Application reference: 25/0781/FUL

Proposal: Demolition of multi-storey car park and construction of a co-living development alongside public realm improvements, landscaping, cycle and car parking, servicing, refuse and recycling provision, and associated works (REVISED PLANS).

Thank you for inviting us to comment on the revised plans for the Mary Arches Redevelopment. Our response below is thought to be in addition to our previous responses, especially where they refer to the use of this site for Co-living rather than residential 1-, to 4-bedroom inner-city flats and to the harm the development will cause. Even with the alterations now presented the proposed scheme still increases building height and mass, which would harm the Conservation Area and setting of Listed Buildings; and the view of St Michael's Mount Dinham from Fore Street will be largely lost. We see the deferred scheme still as what the officer's report called 'a missed opportunity to repair the harm caused by post war development' and that is contrary to the NPPF requirement to enhance or better reveal significance, not to entrench decline.

Diagram 01

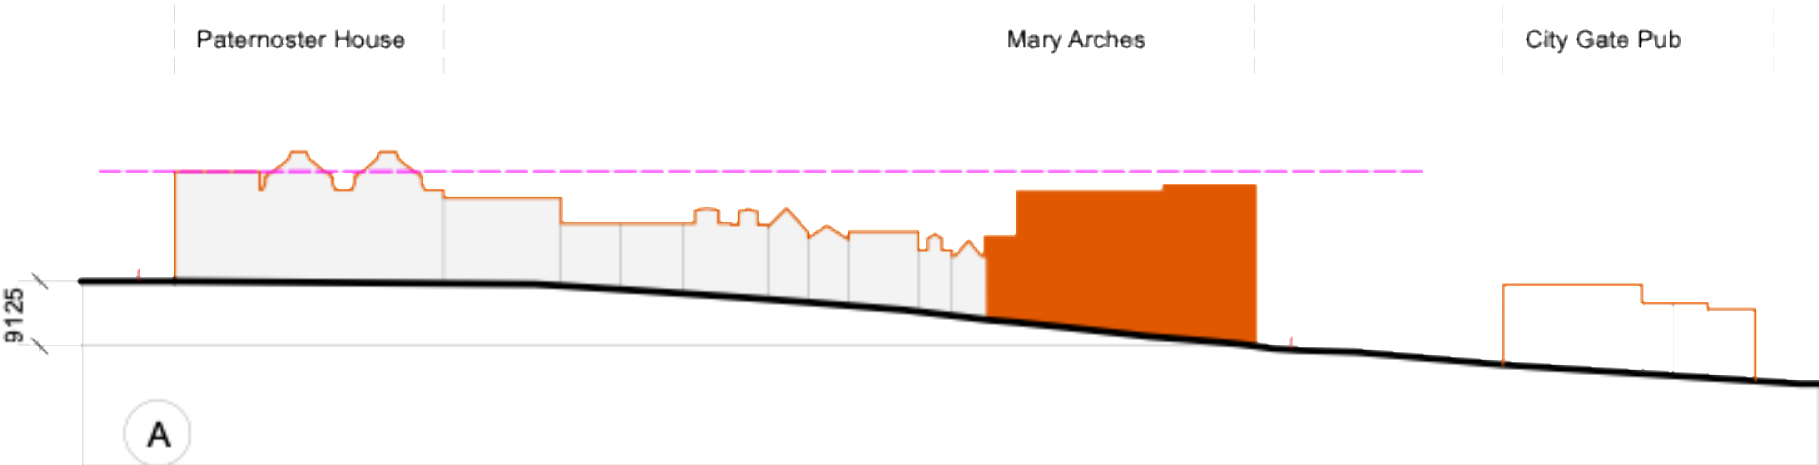
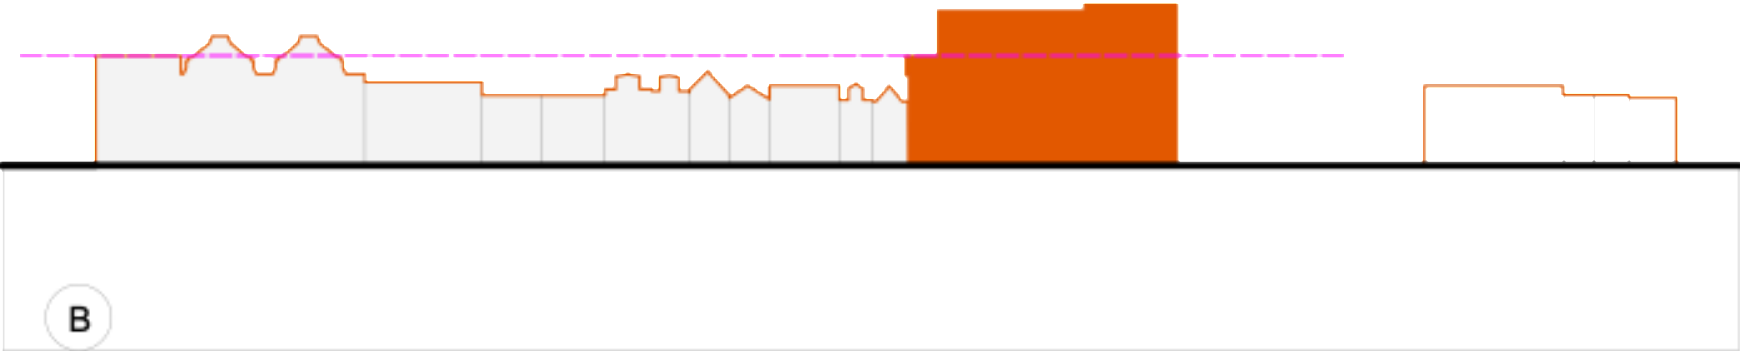
Critically, the proposal fails to respond to the established vertical rhythm, hierarchy, and grain of North Street. This results in a discordant and incongruous intervention within an otherwise coherent streetscape. See our Diagram 01 (in the attachment).

The purpose of this diagram is to show the real perceived massing of the proposal set against the eaves line along North Street.

While the natural slope of North Street might partially mask the building's height from certain angles, the "flat line" analysis demonstrates that the proposal relevant to the street level it represents a substantial increase in massing compared to the historic eaves line.

- **The Eaves Line of Paternoster House:** A dashed magenta line tracks the consistent height of the existing street frontage of Paternoster house
- **Topographical Slope:** The ground line slopes downward from Paternoster House toward the City Gate Pub.
- **Proposal Impact:** The proposed building (highlighted in solid orange) sits significantly higher than the immediately adjacent structures

- **Flat Line Adjustment:** By levelling the ground line, the diagram isolates the height of the proposed structure relative to its neighbours.
- **Height Differential:** In this view, the "true scale" becomes more apparent; the proposal appears as a much denser, taller block compared to the finer grain of the existing North Street buildings.

Diagram 02

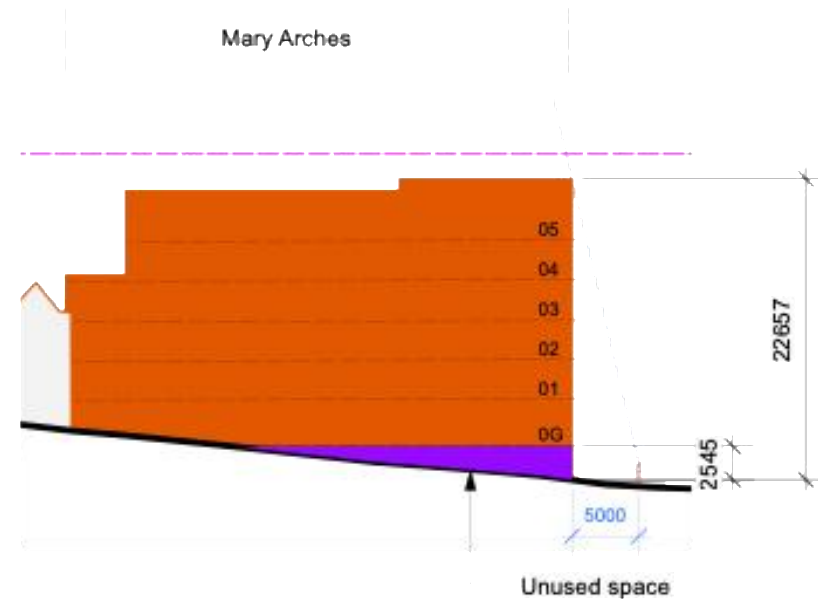
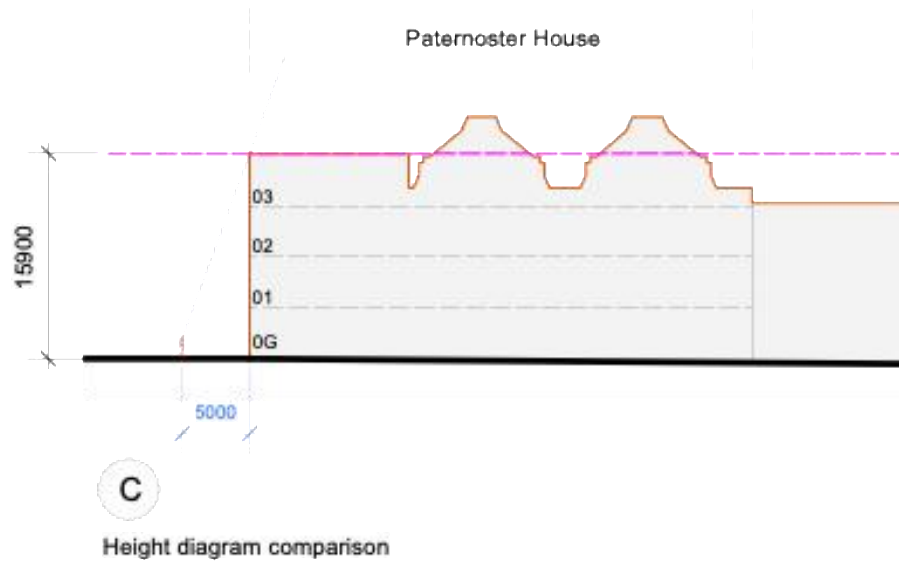
The scheme fails to draw on the richness of detailing, hierarchy, and material expression that characterises the surrounding built environment. This represents a missed opportunity and reinforces the scheme's lack of contextual sensitivity. See our Diagram 02 (in the attachment).

- The height comparison highlights a significant disparity in both physical height and how that height is managed visually
- The Paternoster building is 15.4m high at the eaves, with a 4th floor set back from the main elevation with only the historical turret visible from the street.
- The Mary Arches proposal is 22.6m high with no setback.
- Ground Level and "Unused Space": The 6-storey proposal appears even taller because it sits atop an "unused space"(highlighted in purple) created by the sloping ground.
- A 1.7m tall person (set 5m from the building) has been drawn to show how the building massing and height are perceived

- Paternoster House features highly detailed and refined elevations, characterised by a sophisticated rhythm of **solid to void** and an articulated roof eaves line
- In contrast, the Mary Arches proposal appears **monotonous and bland**, lacking detail and articulation

Diagram 03

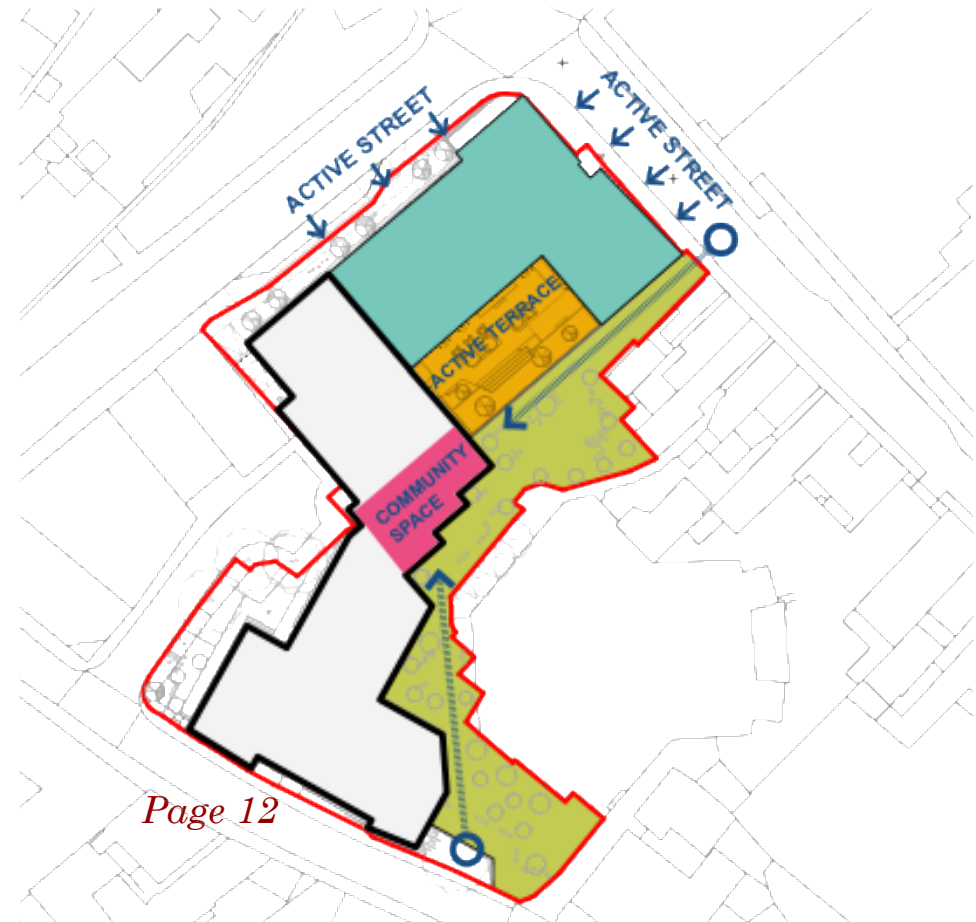
The current plans do not offer any potential connection for use of the facilities/amenity spaces to the public, neighbour or guests, thereby severely limiting any potential integration and making the redevelopment an island within its neighbourhood. See our Diagram 03 for more details (in the attachment).

No connection or positive contribution to the local neighbourhood

We have noted that the latest design changes have drastically reduced the amenity communal areas at ground floor. The London Plan set clear parameters for integrating LSPBSL into the neighbourhood and its surroundings as part of encouraging good quality and lasting design. The proposal, its design and articulation of the amenities fail to include this into the proposal.

The current plans do not offer any potential connection for use of the facilities/amenity spaces to the public, neighbour or guests, thereby severely limiting any potential integration and making the redevelopment an island within its neighbourhood.

- Mixed use spaces open the local community
- Active public amenities
- Shared working area

- Mixed-Use Spaces: Opening areas specifically for use by the local community rather than just residents.
- Active Public Amenities: Designing the ground floor to front the street with high-energy uses.
- Shared Working Areas: Implementing communal workspaces that are accessible to external guests to promote integration.
- Spatial Strategy: Active Terrace and a dedicated Community Space to bridge the gap between the private development and the public realm.
